#### RE: Albuquerque ER & Hospital 4315 Wyoming Blvd NE Grading and Drainage Plan Engineer's Stamp Date: 11/2/21 Hydrology File: G19D004D

Based upon the information provided in your submittal received 11/2/2021, the Grading & Drainage Plan **is not** approved for Building Permit, and for action by the DRB on Site Plan for Building Permit. The following comments need to be addressed for approval of the above referenced project:

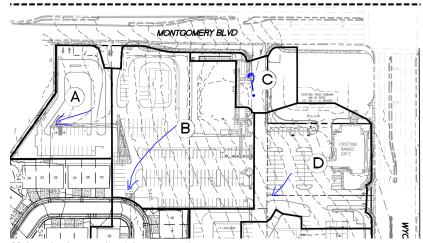
- 5. What offsite drainage is this accepting?
- 6. How will the drainage for this site get to the are shown on the master G & D? Please elaborate and clarify on this submittal. Please show how this site ties into adjacent properties with spot elevations.
- 7. The plan calls out retention of the Water Quality Volume for this parcel. Where is this information? I do not see any retention areas. Label ponds and volume for each.
- 8. Provide a legend and note existing vs. proposed contours on it. What is the grey circle?

9. Is this a retaining Wall? If so call out and provide a detail.

10. What is this slope? Will a retaining wall/stem wall be necessary? Please provide a detail/section. Slope looks too steep to stabilize as shown.

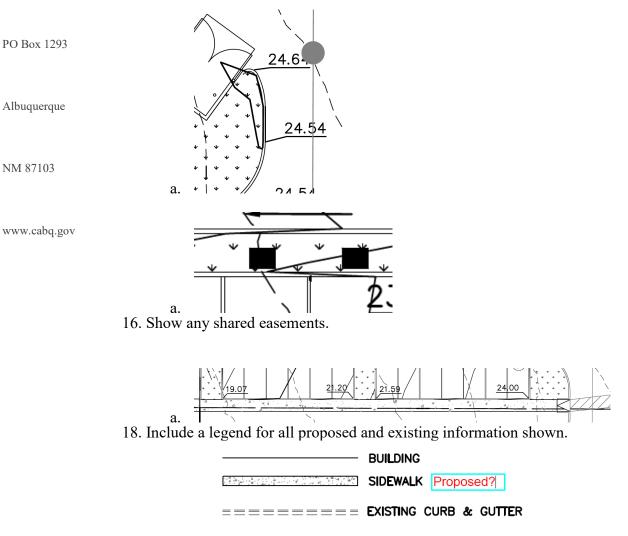
- 11. Please add a note under Grading Notes. "Side slopes need to be stabilized with Native Grass Seed (per City Spec 1012) with Aggregate Mulch or equal (Must satisfy the "Final Stabilization criteria" CGP 2.2.14.b.)".
- 12. Provide a section of the stem wall.
- 13. Provide downstream capacity and Storm Water Quality control.

**GRADING PLAN**

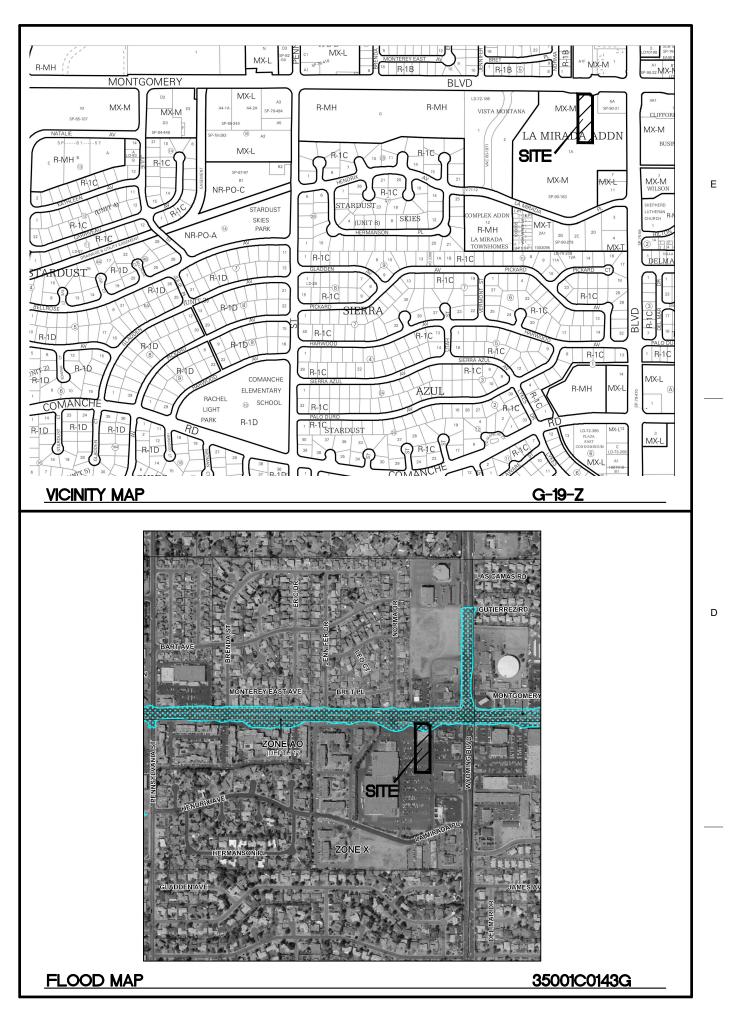
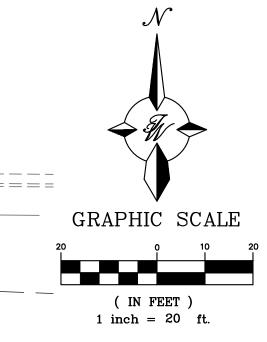
- 1. Please provide results from DPM Part 6-2(A) regarding what zone the property lies in and associated rainfall and calculations. No information was included to specify existing or proposed flows.
- 2. Part of this submittal, specify where drainage is going and the drainage area. Currently this site drains to the west. According to the master drainage plan G19D004, that is currently under review, you had a small portion of this site draining to Montgomery that currently does not drain towards Montgomery and will not be allowed. Explain how this will now drain. Please reference the master drainage plan and ensure it aligns with it.
- 3. Existing Drainage:

4. Proposed Drainage:
